RELEASE FOR CONSTRUCTION AS NOTED ON PLANS REVIEW CODES ADMINISTRATION LEE'S SUMMIT, MISSOURI

KH-6105 (THE CYPRESS) LOT 121

THE "CYPRESS"

1634 SE BLACKSTONE PL. LEES SUMMIT MO LOT IZI NAPA VALLEY

BASEMENT PLAN

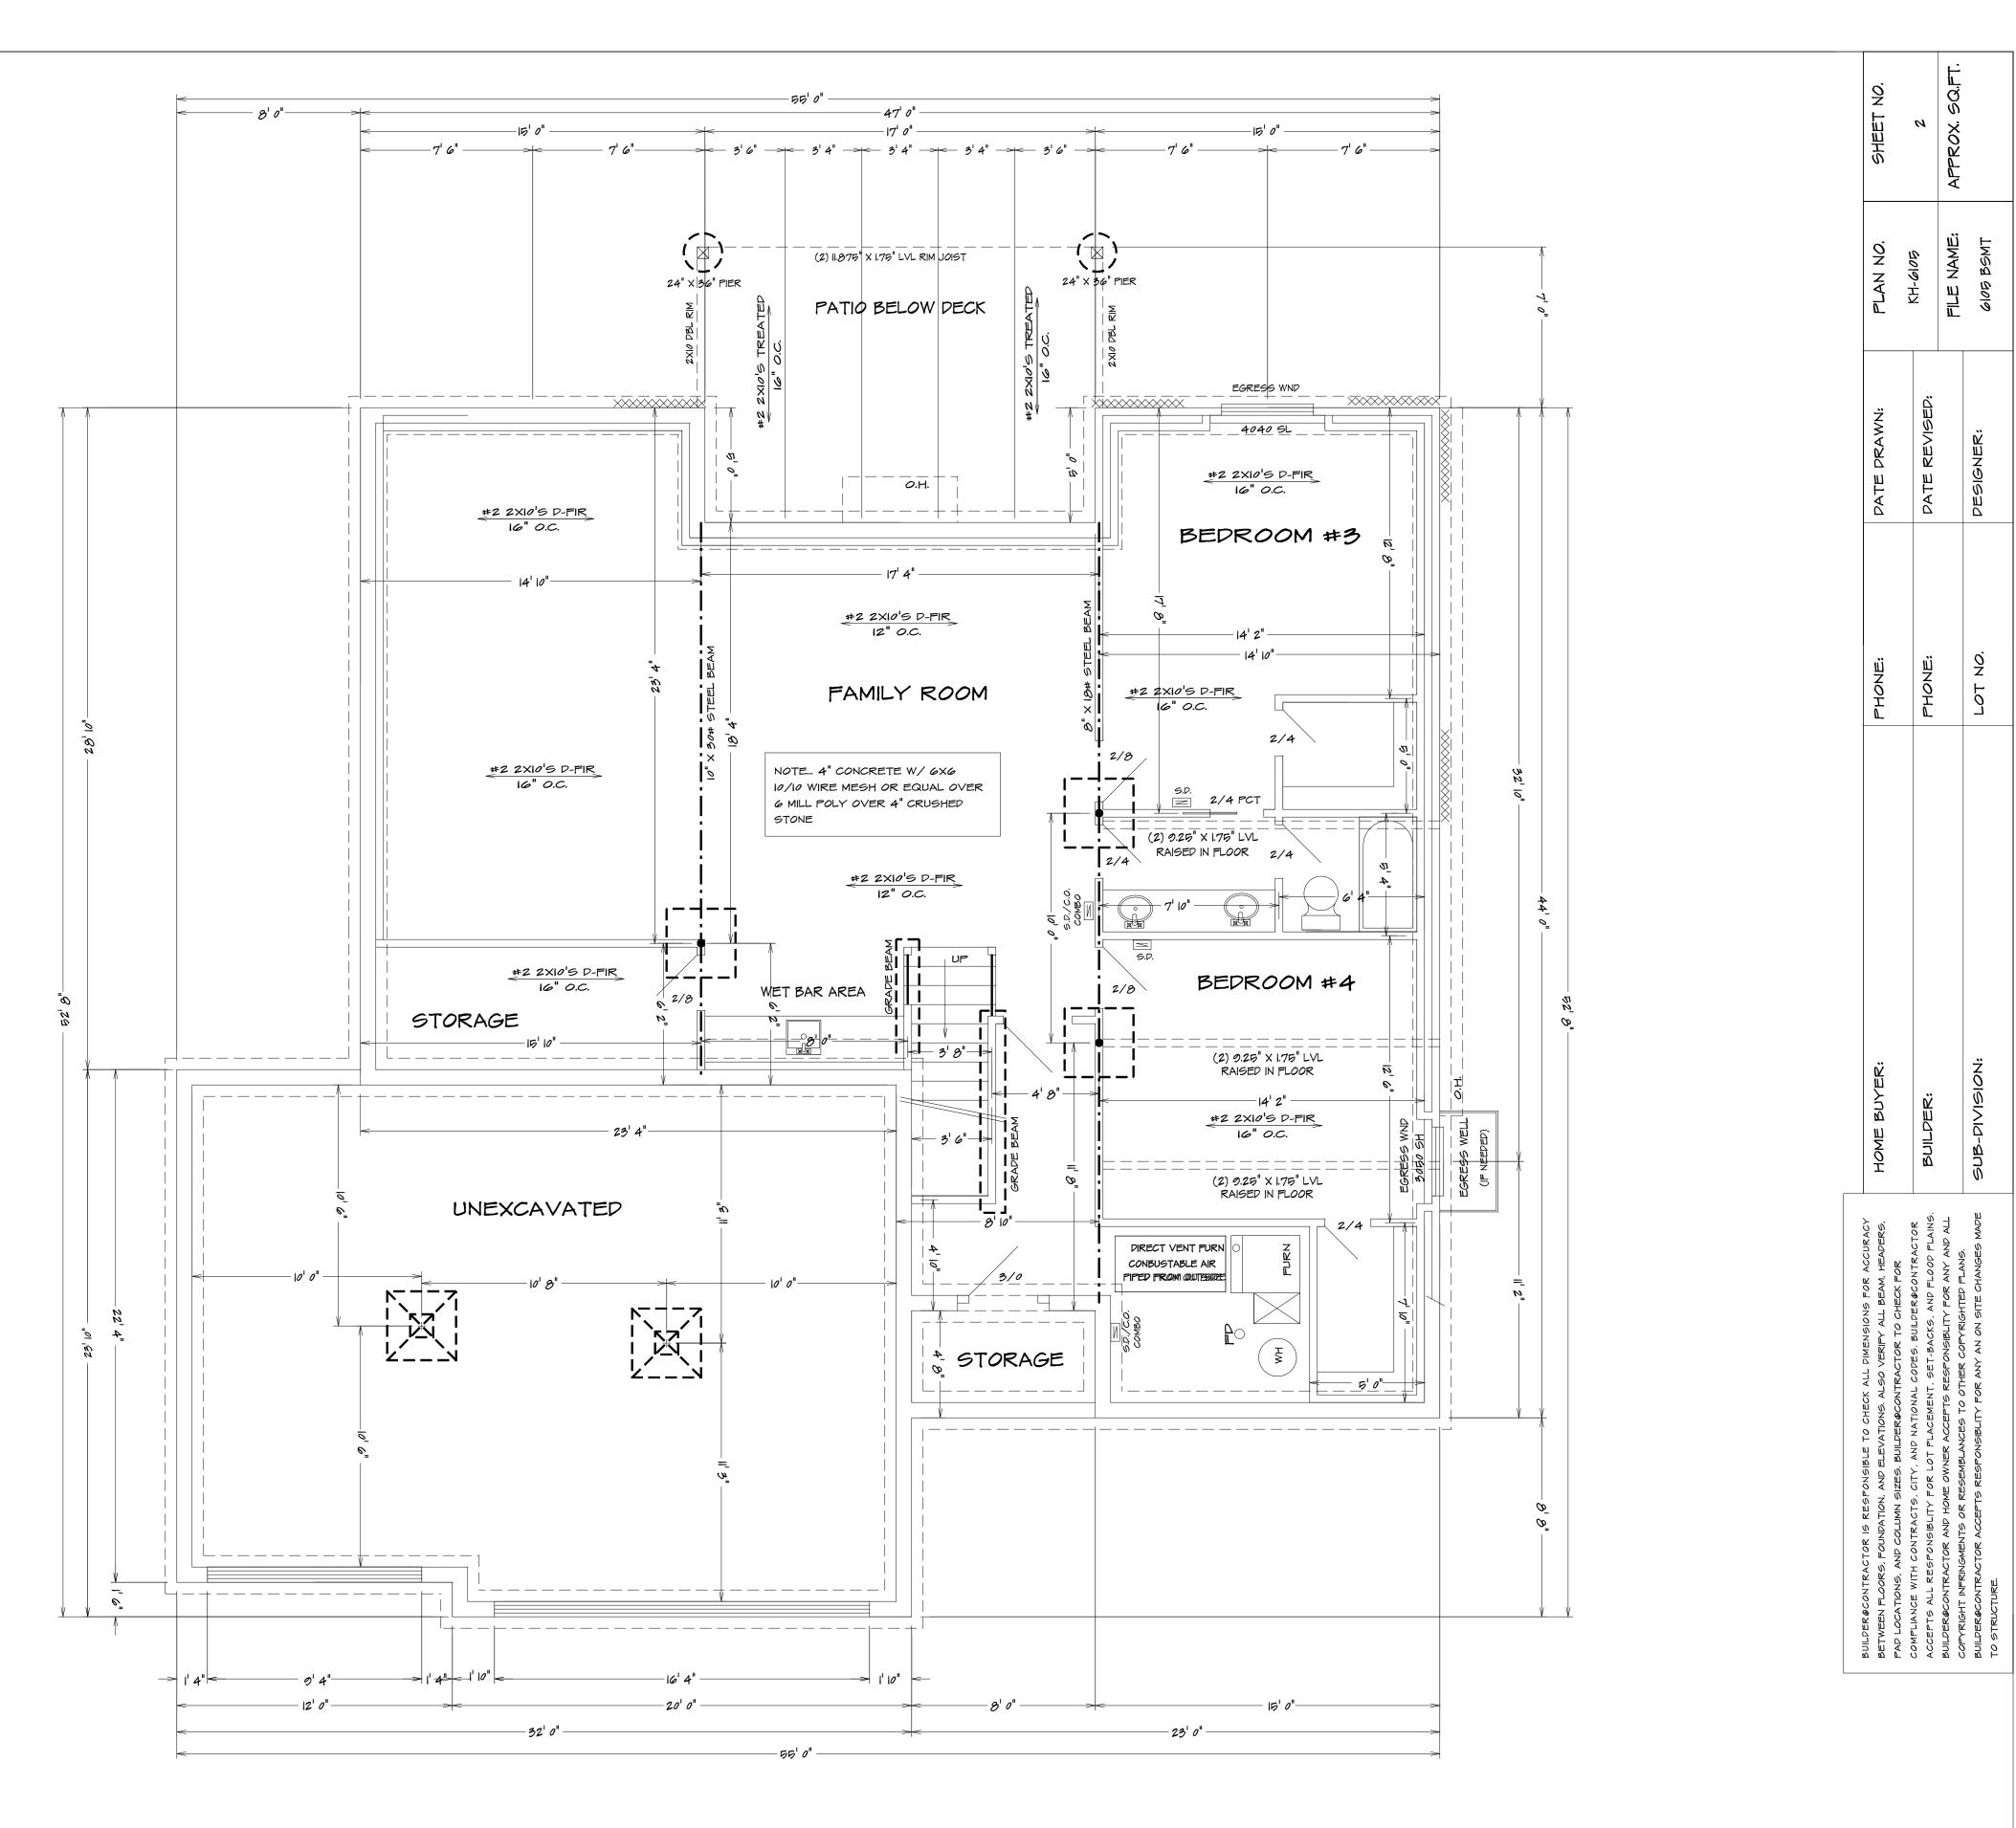
Note...Bridging. Joists exceeding a nominal 2 inches by 12 inches shall be supported laterally by solid blocking, diagonal bridging (wood or metal), or a continuous 1-inch-by-3-inch strip nailed across the bottom of joists perpendicular to joists at intervals not exceeding 8 feet. (R502.7.1)

FIRST FLOOR PLAN

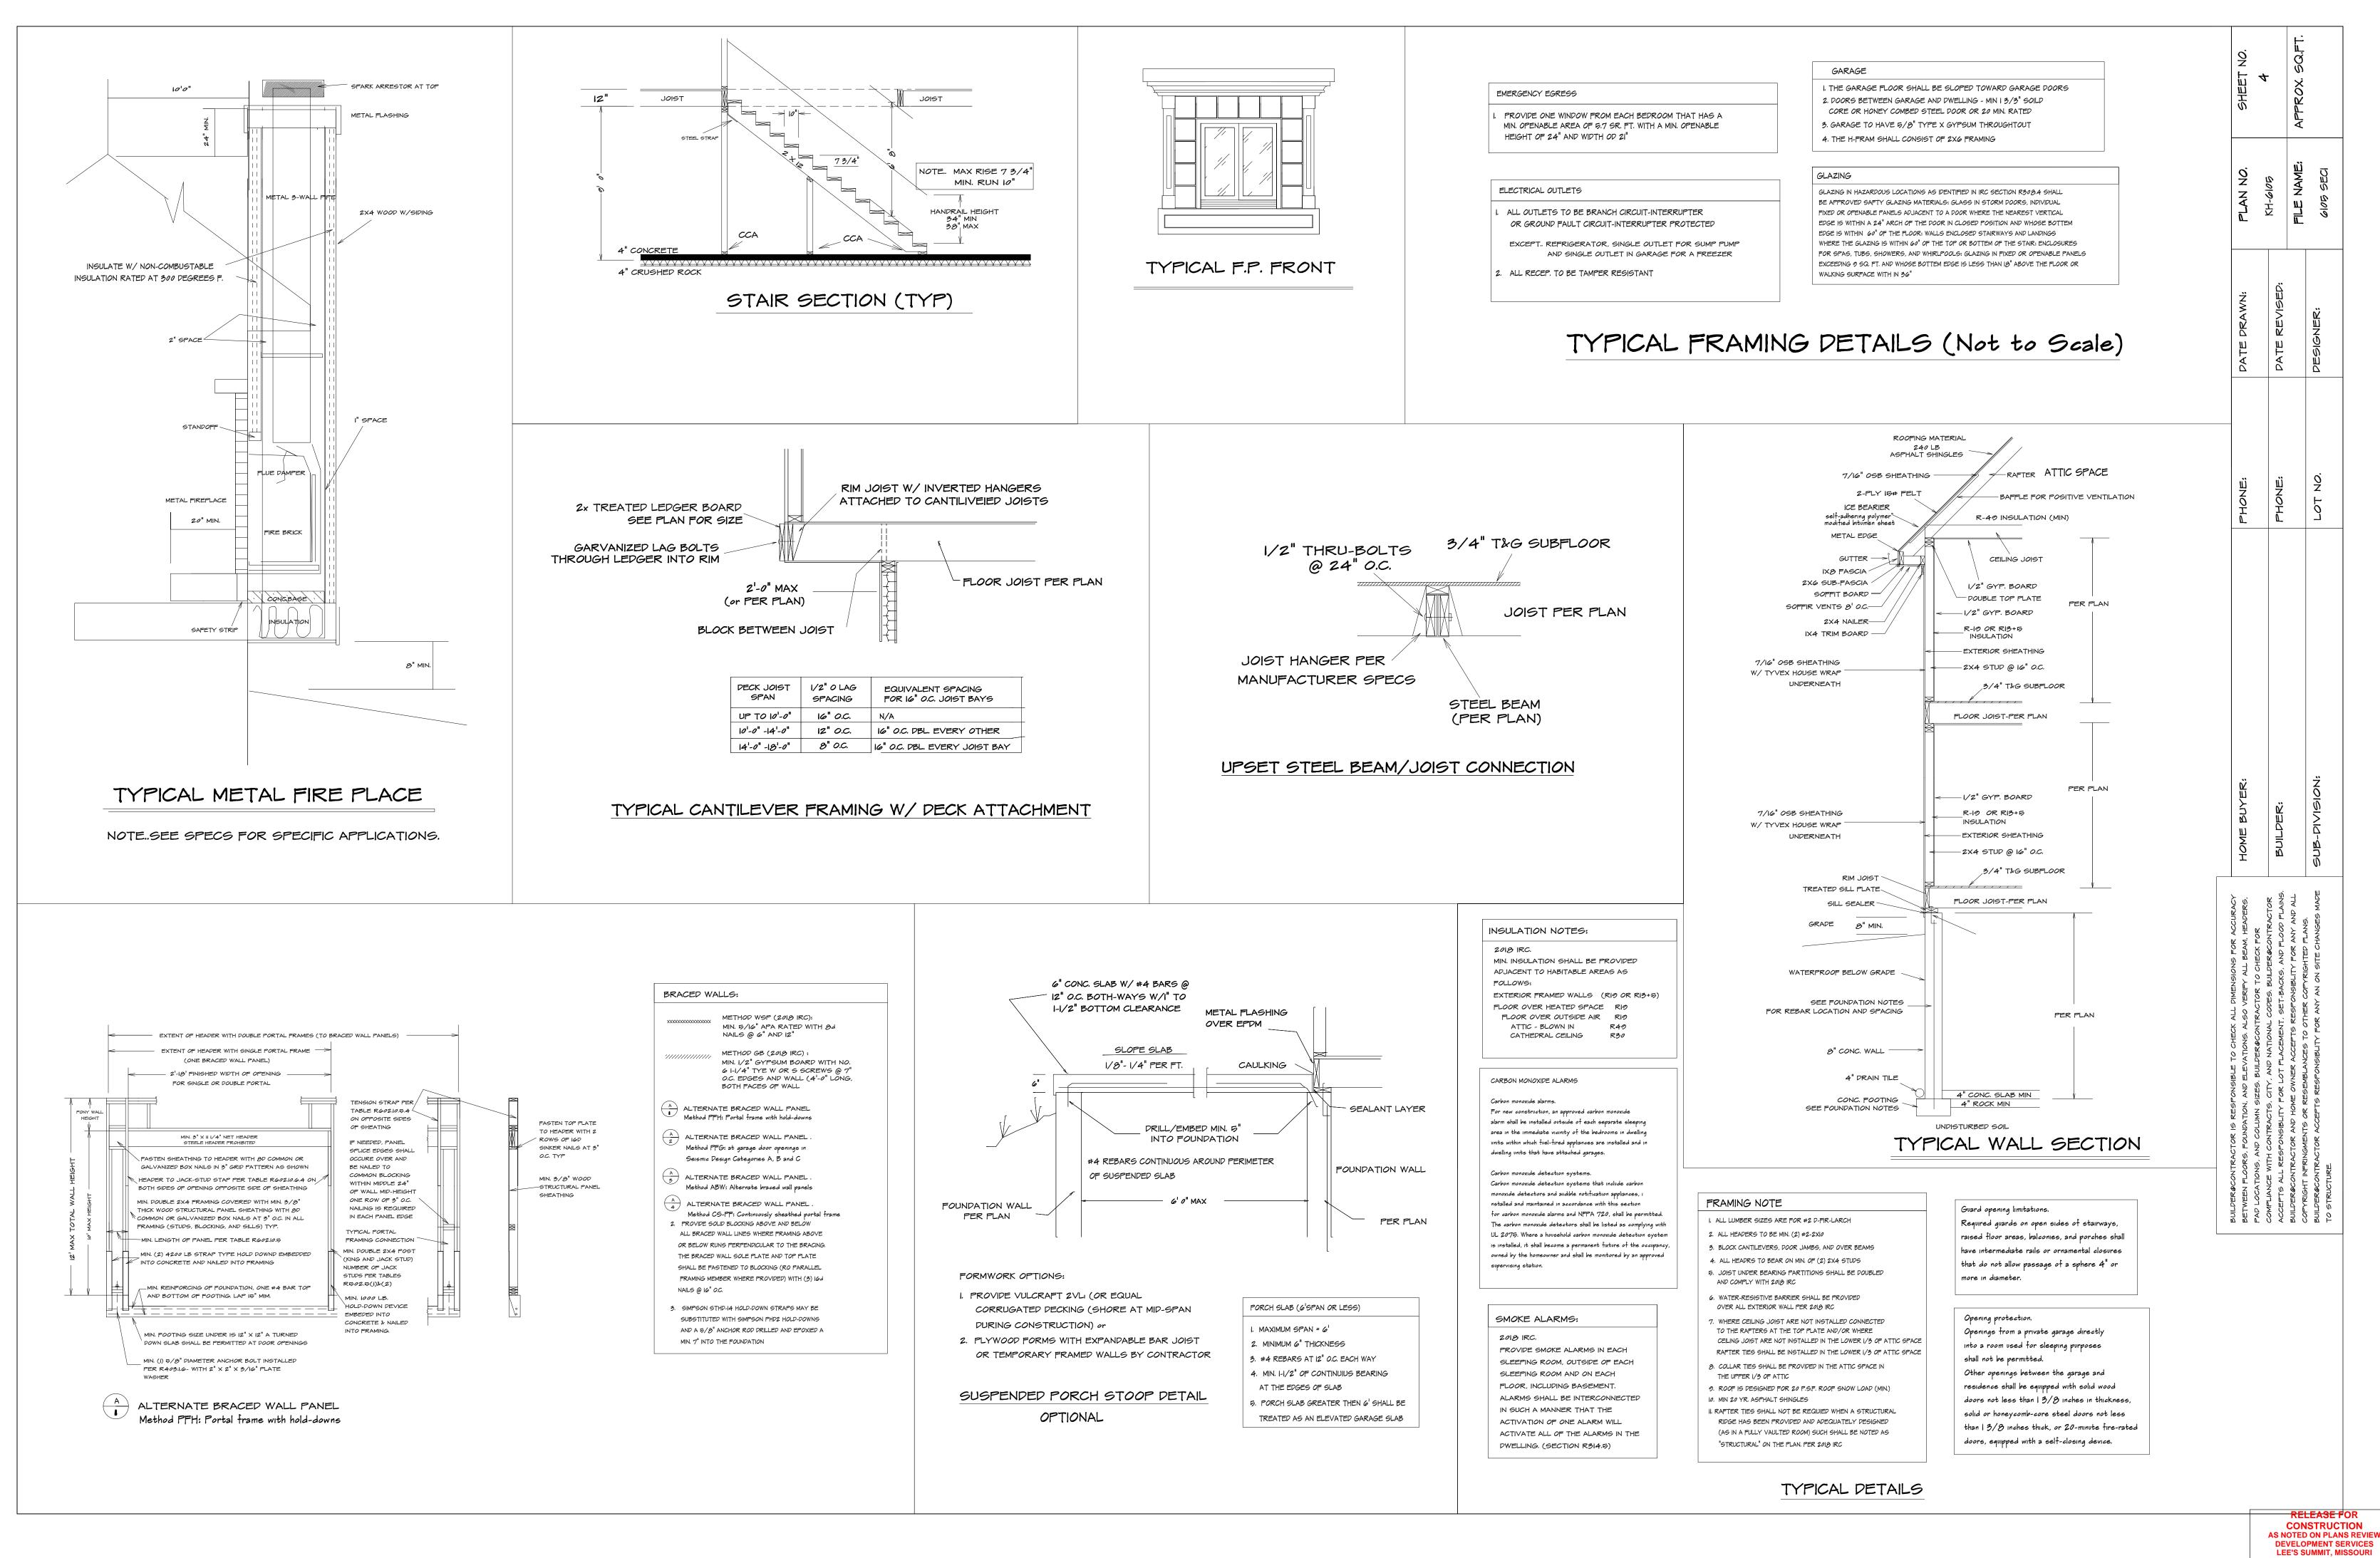
Bathrooms, water closet compartments and other similar rooms shall be provided with aggregate glazing area in windows of not less than 3 square feet, one-half of which must be openable. Exception: The glazed areas shall not be required where artificial light and a local exhaust system are provided. The minimum local exhaust rates shall be determined in

accordance with Section MI507.

Exhaust air from the space shall be exhausted directly

to the outdoors.
